ASHMORE PRECINCT DRAFT DCP REVIEW URBAN DESIGN STUDY AND LANDSCAPE FEASIBILITY STUDY

23rd March 2006

Report prepared for City of Sydney Council

36,37 Figure 28, 29

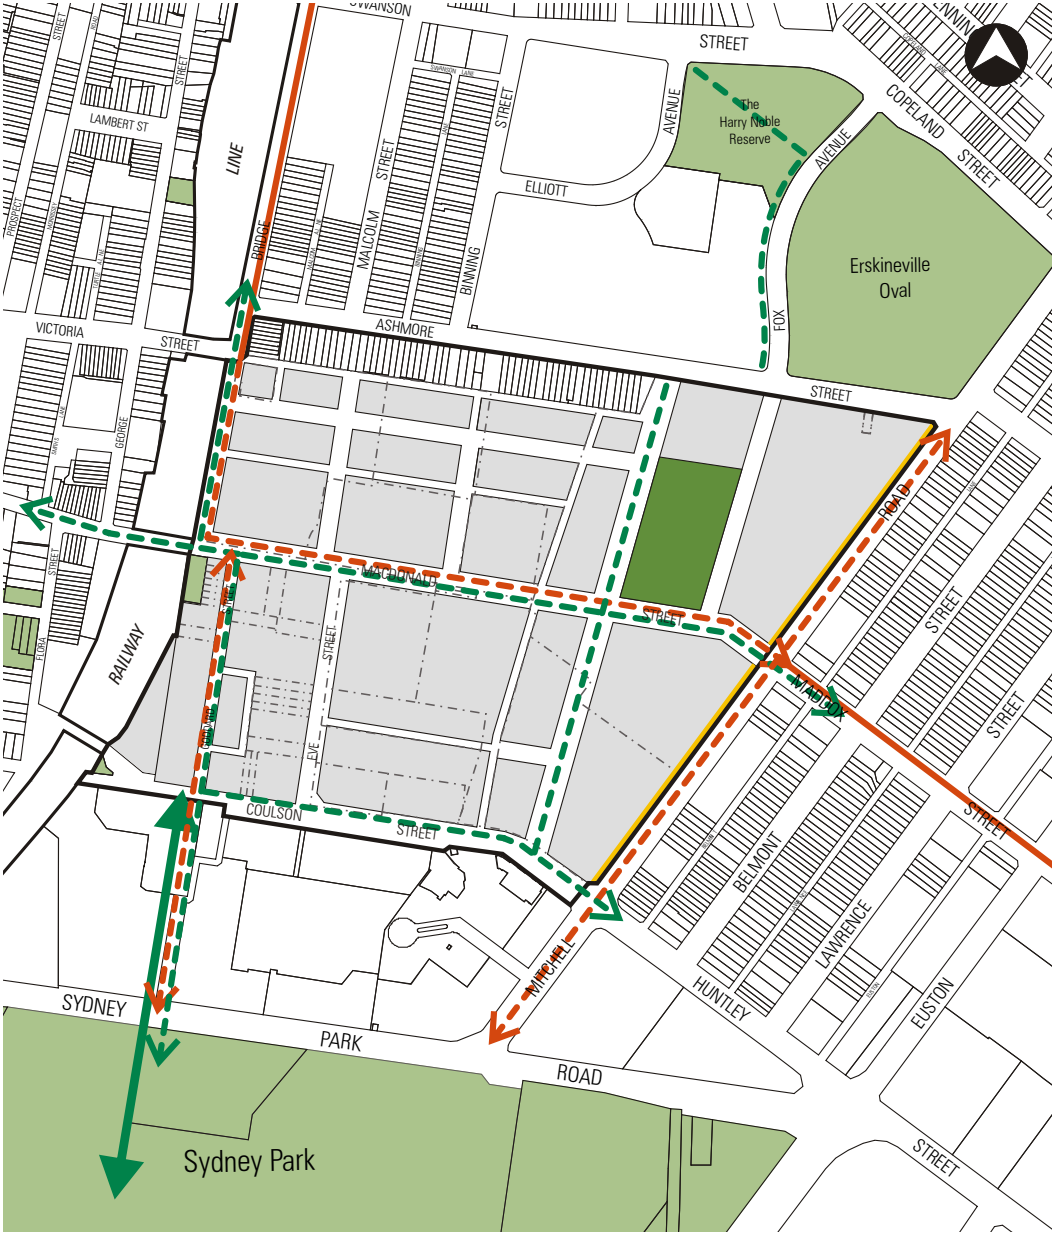
- Again section and plan not clear to read.
- Concerns over the swales suggested for the local streets as they reduce the on street parking which will be required for visitor and resident parking. They will become maintenance problems as people will park on them because of a flush kerb at the road edge.
- It might be more appropriate to collect the stormwater traditionally and store it in a tank for use it for irrigation to public parks and street trees.

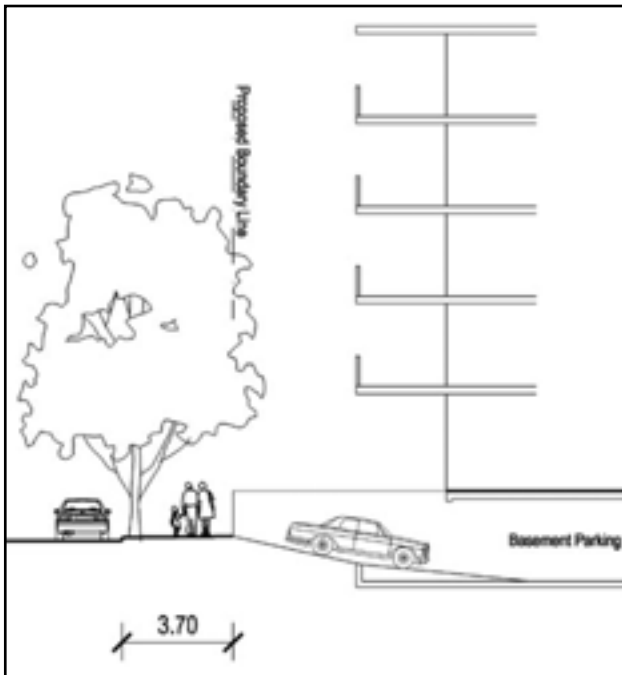
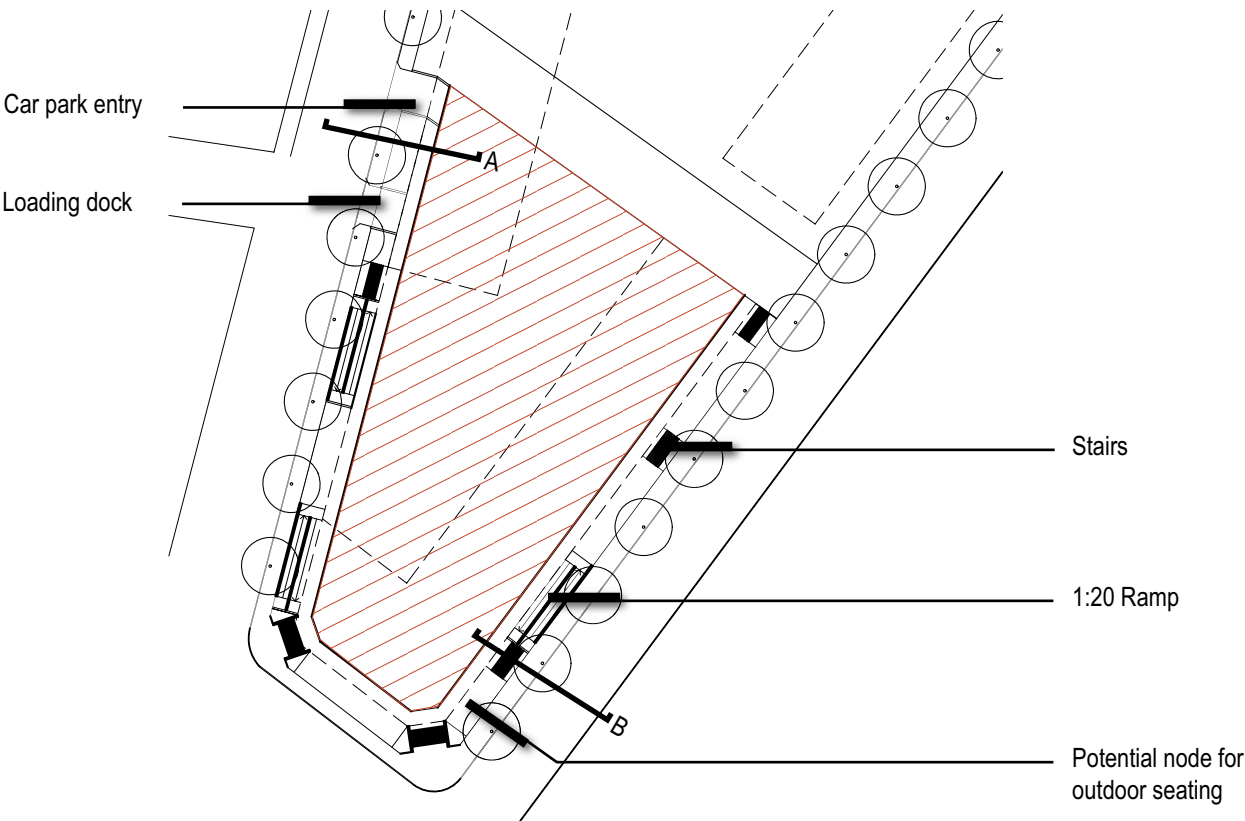
- Supports and enhances the intersection of Mitchell Road and Coulson Street as a commercial node, to compliment the existing in Sydney Park Village.
- Capitalises on valuable land with high exposure to passing traffic assists with the viability of new commercial uses.
- Could enhance the urban structure of both Mitchell Road and Coulson Street by providing a balance to the recent development on opposite sites in terms of height and bulk.
- Strengthen the structure of the intersection with a positive corner development activating both streets.

- Set in flood prone land with the requirement of the floor levels to be approximately 1.5m above existing pavement levels. This provides poor access, both visually and physically, from the street and would reduce the viability of the land for commercial uses. Long ramps would be needed to provide access up to 30m in length plus landings and if located along the boundary of the site then direct access would be greatly limited from street level.
- Such elements would restrict the potential to build on the historic fine grain rhythm of the built form of this area, typically narrow and vertical, as one of the objectives in the draft DCP. This would have a negative relationship with the properties adjacent.
- Limited parking provisions in adjacent streets.
- Issues for basement use, costly, infrastructure below.

Diagram based on drawing provided by Turner + Associates.

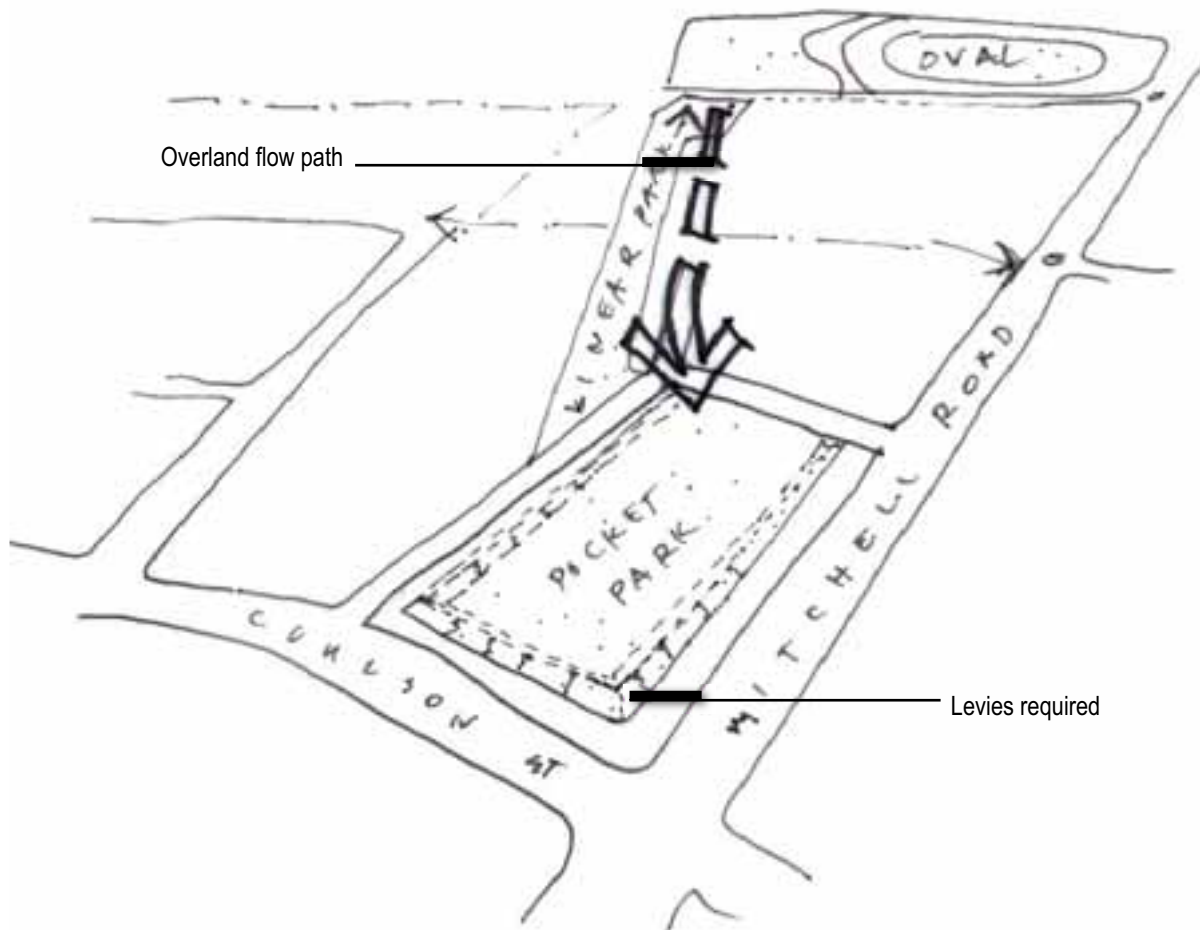
- Could be well connected with a potential new cycle way / pedestrian connection between Erskineville Oval and Sydney Park on Mitchell Road.
- An underground detention tank could be used under the park (depending on the invert levels of the storm water pipe directly down stream) allowing the surface of the park to be at foot path level. This would be of benefit to the community as access would be achievable from all angles and has better visual connection with the local neighbourhood providing better security.

- If the park is recessed 1.2m from footpath level with 1:4 batters to the sides as a detention basin, it will not assist with the reduction of flood waters at this intersection.

- To be of benefit, levies around the edges would need to be constructed to intercept overland flows and hold them until the flood waters in the intersection recede. This would provide physical and visual barriers from the adjacent streets and would be of limited benefit to the community.

- This position does not allow the new community to focus on this park as a central and integral part of their community.
- The strong built form of Mitchell Road would be reduced thereby reducing the experiential quality of the street.

- High water table may cause the park to be permanently damp and may release contaminants into the park (based on Douglas and Partners investigations of 165 Mitchell Street with the water table being 1.5m below ground level).
